BART Seismic Retrofit Project

Berkeley Hills Tunnel to the Montgomery Street Station

ENVIRONMENTAL ASSESSMENT

Response to Comments

Figure 5. San Francisco Transition Structure Construction Phase 3

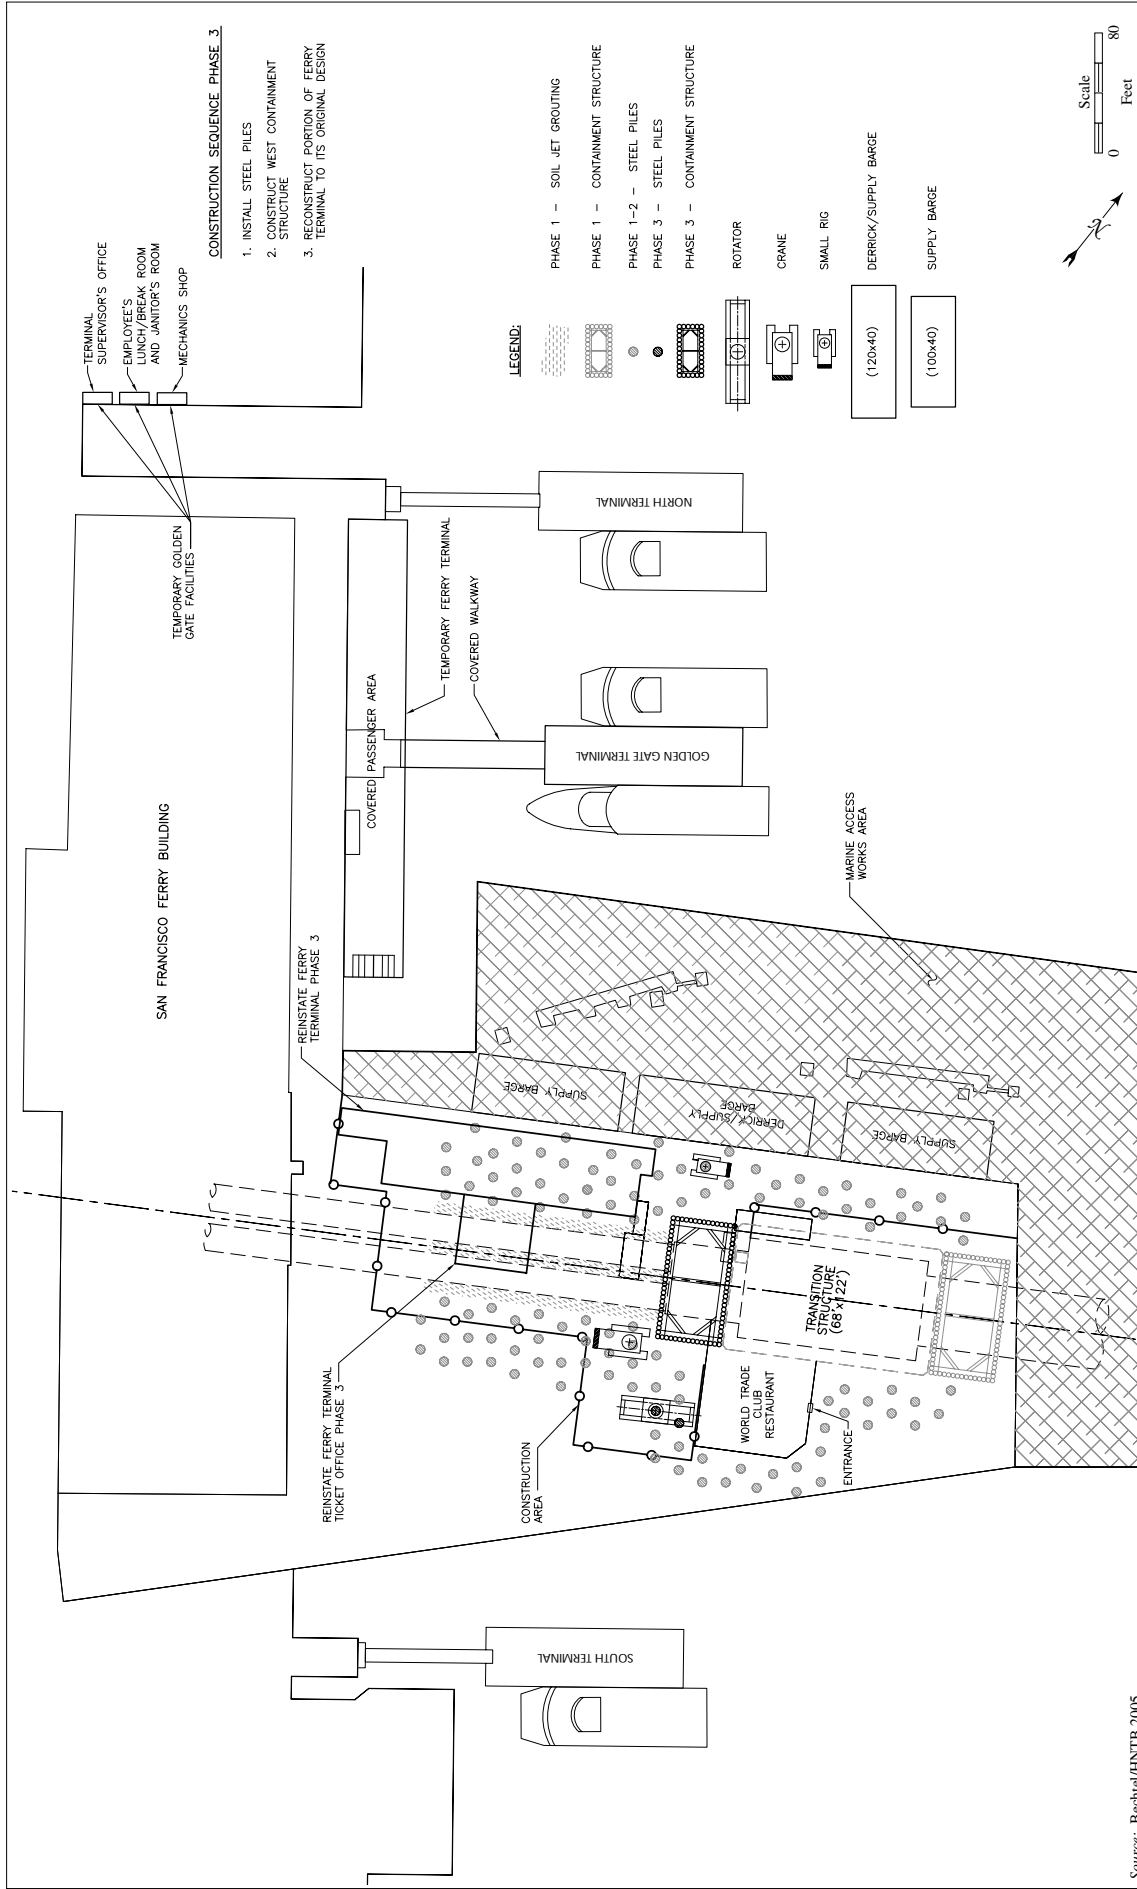
23 Phase 3 construction would require closure of a central portion of the Platform to accommodate
24 installation of up to four steel pipe piles associated with the Pile Array, and the west end
25 containment structure (see Figure 5). Closure of public access areas would be required to
26 accommodate the construction equipment, including a crane, a rotator, a small rig, and
27 construction supply barges. Reconstruction of a portion of the Platform when space is made
28 available would occur before the beginning of Phase 4 construction activities. The anticipated
29 construction area and the marine access work area are depicted on Figure 5. All retrofit
30 activities proposed for the transition structure would be concluded during this phase.

Figure 6. San Francisco Transition Structure Construction Phase 4

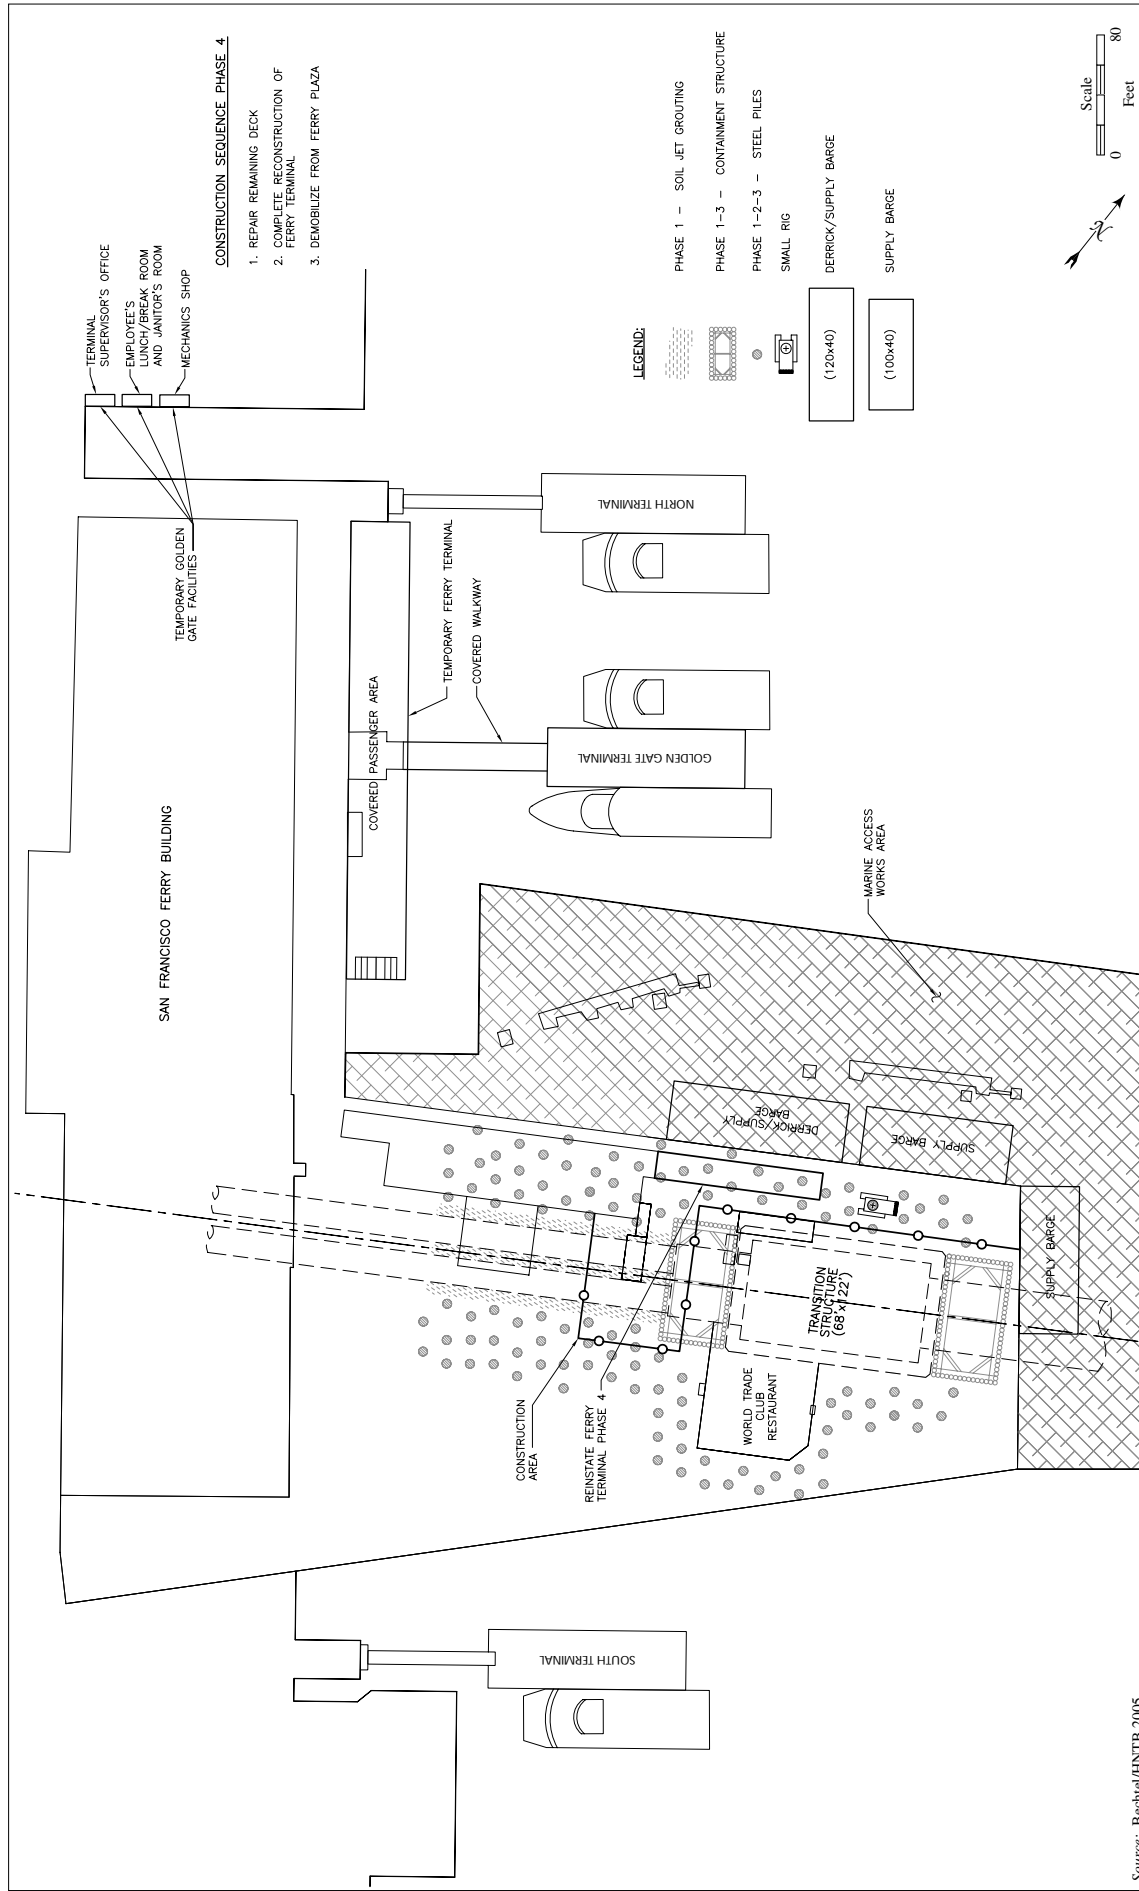
31 Phase 4 construction includes replacement of the remaining portion of the affected Platform deck,
32 reconstruction of the Golden Gate Ferry Terminal infrastructure at the Platform, and
33 demobilization. The anticipated construction area and the marine access work area are depicted
34 on Figure 6. At the conclusion of Phase 4, the Platform would be returned to pre-existing
35 conditions, as well as replacement of hardscape and landscape amenities and public uses.

Figure 7. San Francisco Transition Structure Construction Phase 5

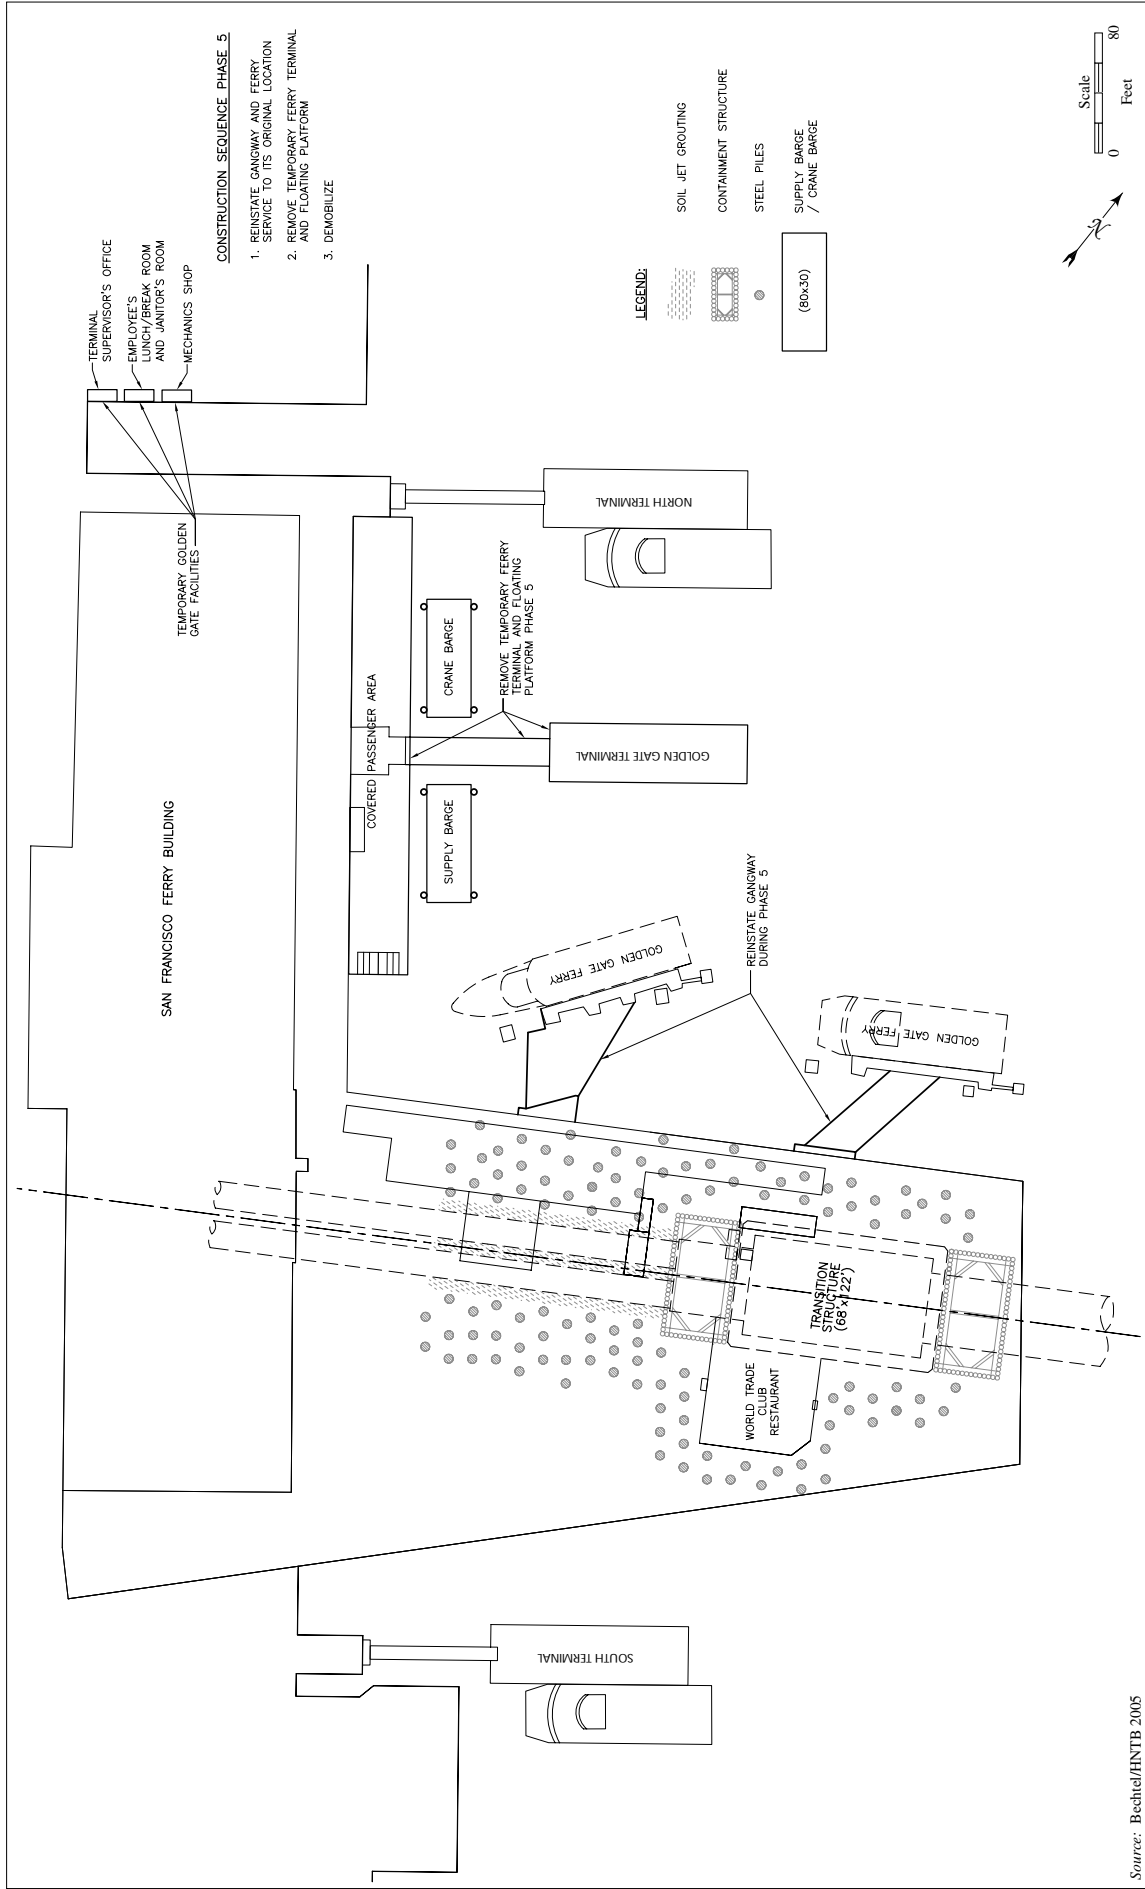
36 Phase 5 construction includes replacement of the original Golden Gate Ferry Terminal gangway,
37 and relocation of Golden Gate District ferry services to its original location on the Platform. The
38 temporary terminal and floating dock at future Gate C, as well as nearby temporary support
39 facilities, would also be removed during this construction phase, and all construction equipment
40 and supply barges demobilized. The anticipated construction area is depicted on Figure 7.

Figure 8. Conceptual Temporary Golden Gate Ferry Terminal

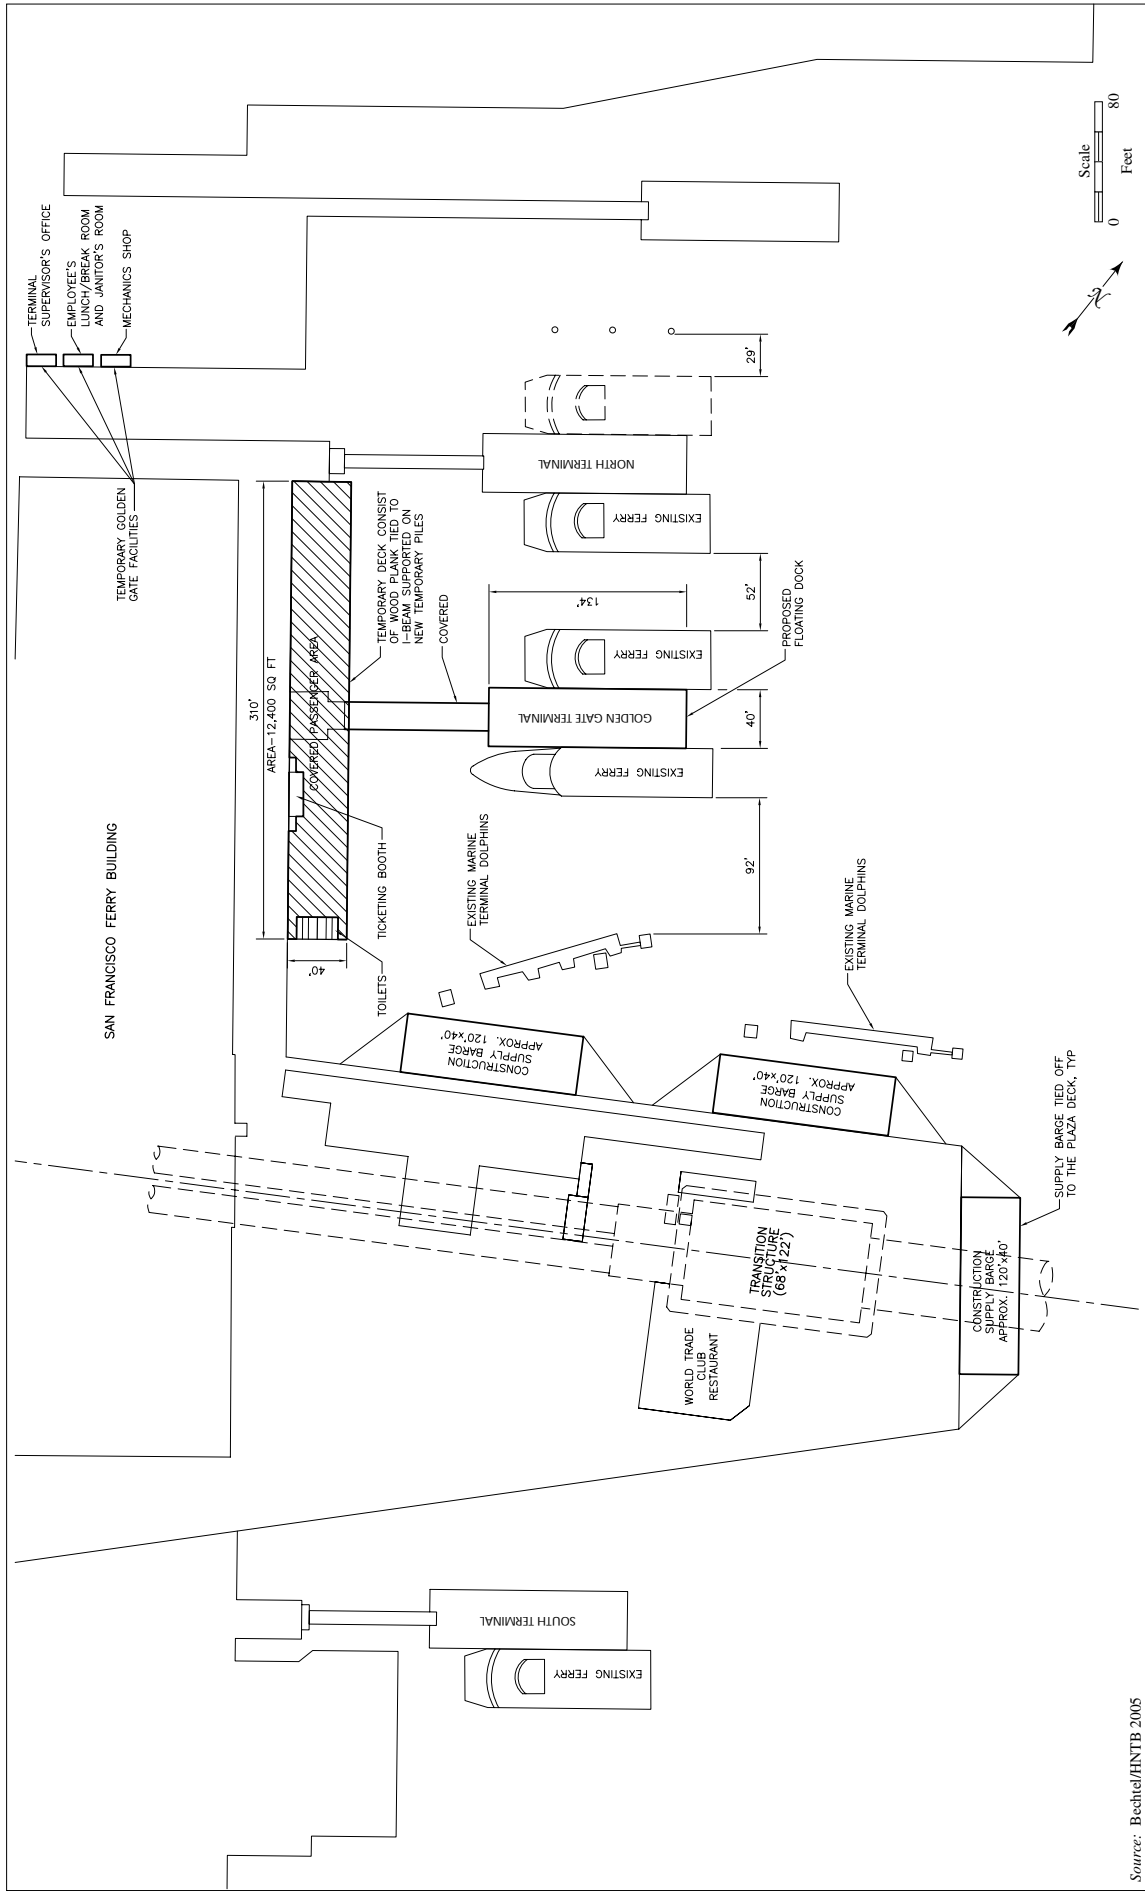
16 housed within temporary trailers. Additional details describing the temporary Golden
17 Gate Ferry Terminal are provided below, and depicted on Figure 8.² The above
18 description is conceptual and both location and exact features of the temporary terminal
19 may be changed during final design, so long as the changes do not create additional
20 impacts, taking into account the applicable mitigation described in the EA.

² The configuration of the temporary Golden Gate Ferry Terminal facilities shown in Figure 8 is intended to illustrate a reasonable worst-case scenario for the extent of the temporary deck for purposes of impact analysis. The specific configuration of the temporary facilities may be revised based on subsequent discussions with the District and the Port, so long as impacts are not materially increased.
